SUBJECT: Waiver of Rules for Late Submittal of a Revised Report concerning BZA Application 16743 requesting a variance for building addition on property located at 1140 Connecticut Avenue N.W.

SUBJECT: BZA Application 16743

In this application, the Charles E. Smith Companies requests a variance to increase the allowable floor area ratio (FAR) limitation of 10.0 under in Section 3103 of Title 11 of the District of Columbia Municipal Regulations (DCMR), Zoning, by 0.061 FAR.

Exhibit 1

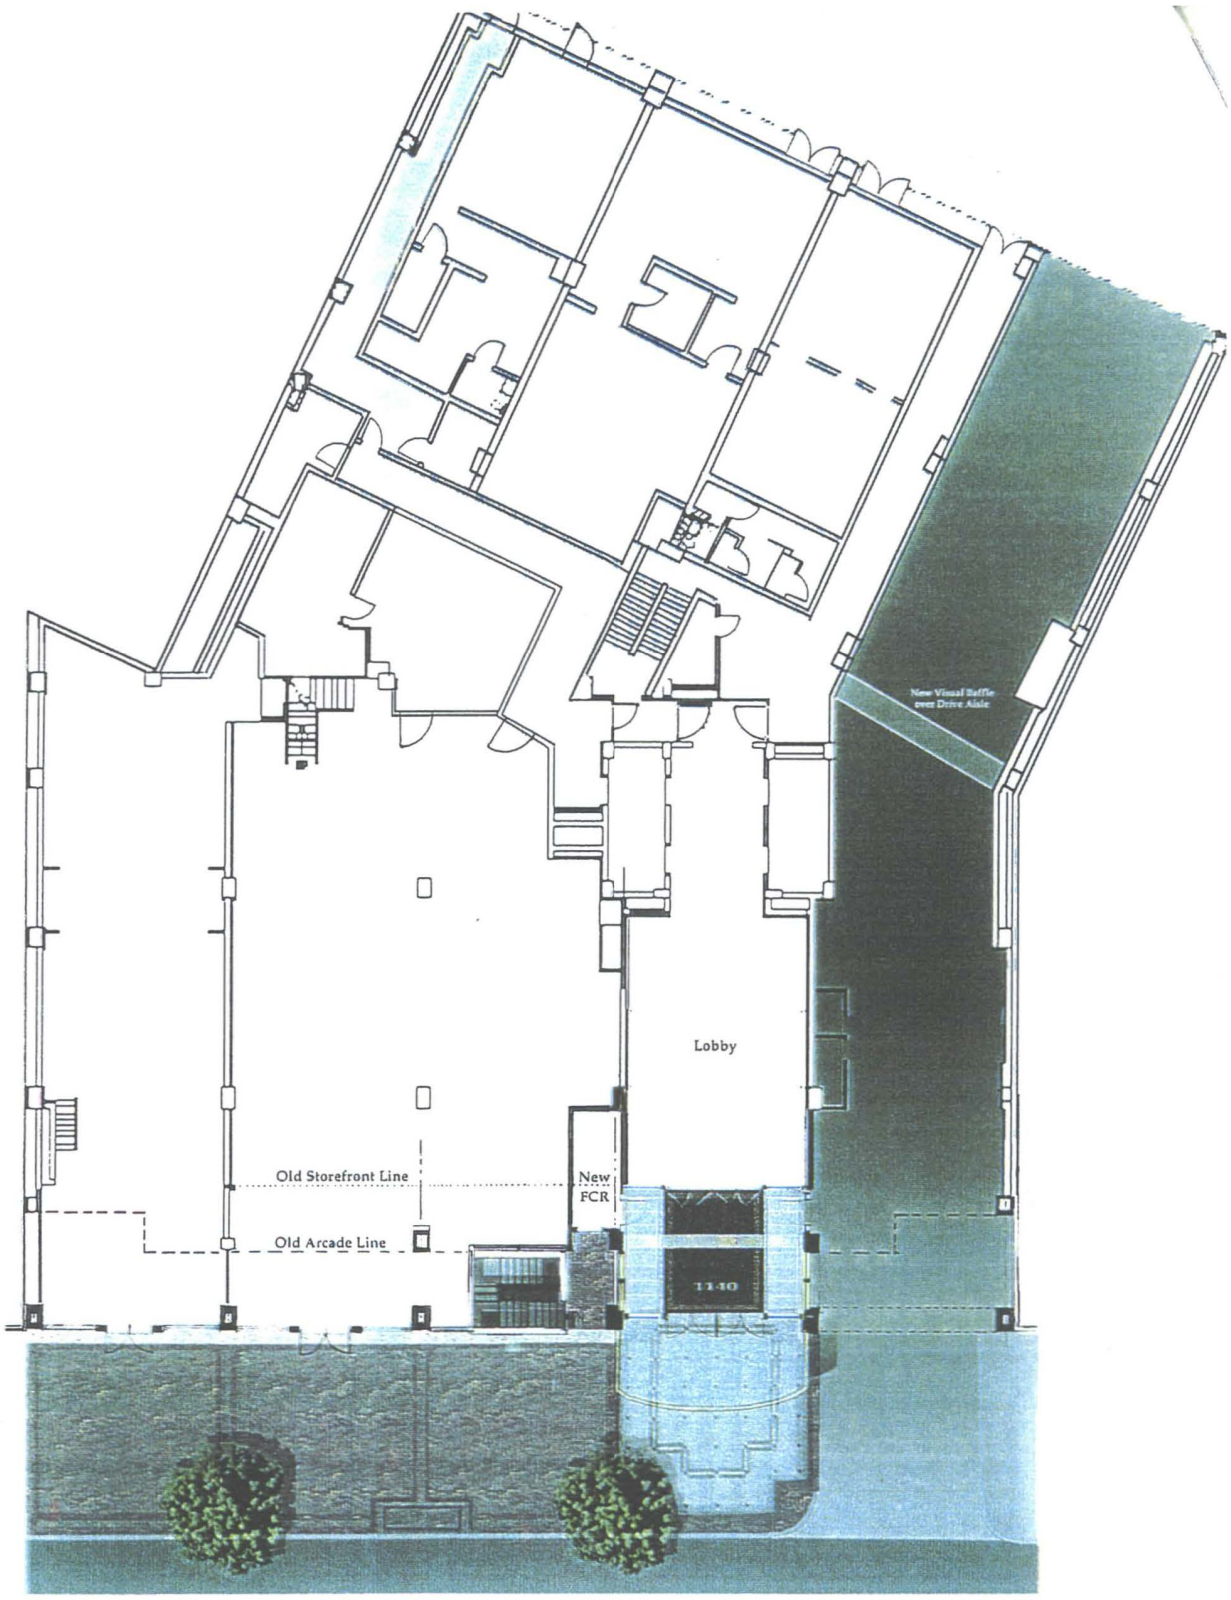
The construction permit for the building "envelope" was approved in 1965. Along Connecticut Avenue, the building frontage is approximately 125' wide (refer to Exhibit 1). According to a plat prepared by the District of Columbia Surveyor, the eastern building façade is generally set-back 10' from the Connecticut Avenue, N.W., right-of-way. In the right-of-way, immediately adjacent to the property boundary, is a wide sidewalk. Portions of the building façade, approximately 14.5'-wide in the northeast and southeast corners, are set back an additional five feet for a total of fifteen feet. The façade is divided into five structural bays: two end bays

As discussed above, the existing storefronts are recessed into the building envelope, so it appears that a portion of the proposed expansion would "fill in" arcade floor area within the building perimeter. Based on this information, staff calculated that the building floor area after the proposed expansion would be as follows:

OP does support approval of a lesser variance to allow the first-floor commercial space to encompass the interior arcade floor area, as recommended in the Comprehensive Plan.

Exhibit 2

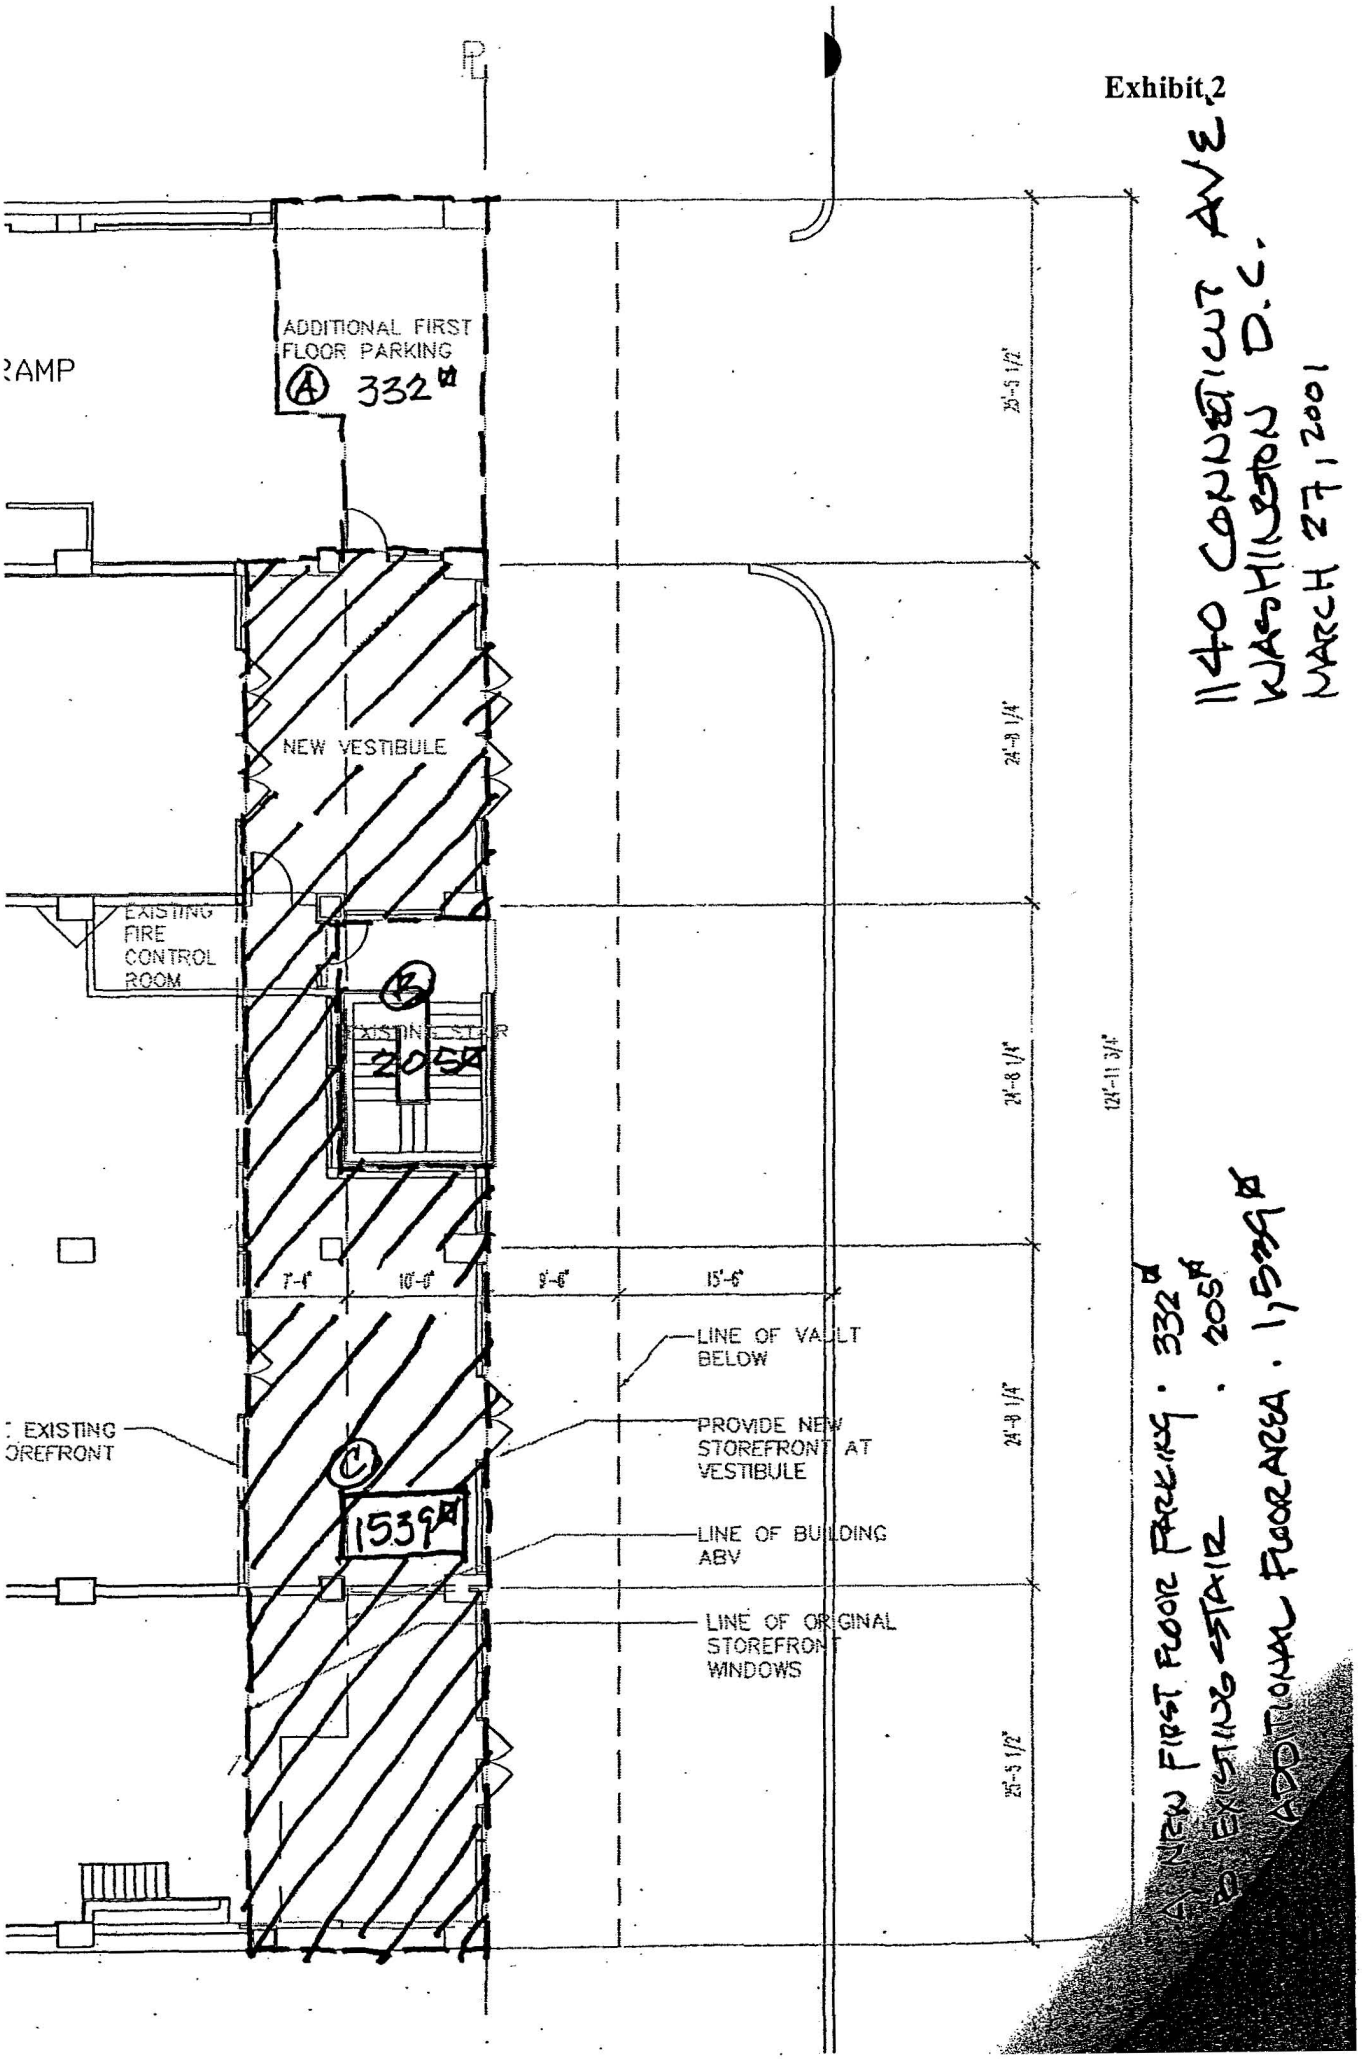
[1] Floor areas based on dimensions shown on Exhibits 1 & 2
